# County of Santa Clara

Department of Planning and Development  
Planning Office

**FILE NUMBER:** PLN22-137  
**SUBJECT:** Building Site Approval and Design Review Tier III  
**SITE LOCATION:** 15581 Glen Una Drive, Los Gatos, CA 95030-2908 (APN: 510-26-007)  
**DATE RECEIVED:** August 2, 2022

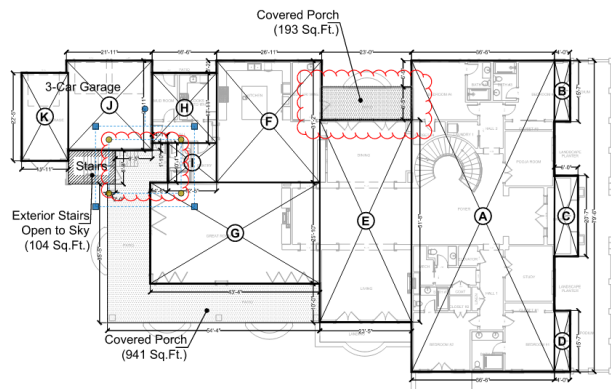
Staff has concerns about the building form, which might not meet the above-mentioned design criteria of the adopted Design Review Guidelines. Please provide a separate sheet for

roof plan to help the staff make the findings for the Design Review Building Form criteria (a). The submitted demarcation of the Roof Plan over the Upper Floor Plan (Sheet A2.0) is not clear enough for the presentation at the Planning Commission to justify the first Criteria for the building form. Provided elevations that are not colored to better indicate the architectural forms.

Please revise the architectural design per criteria (b) and (c) to be consistent with the required design criteria of the adopted Design Review Guidelines document per the Zoning Ordinance Section 3.20.040 (F).
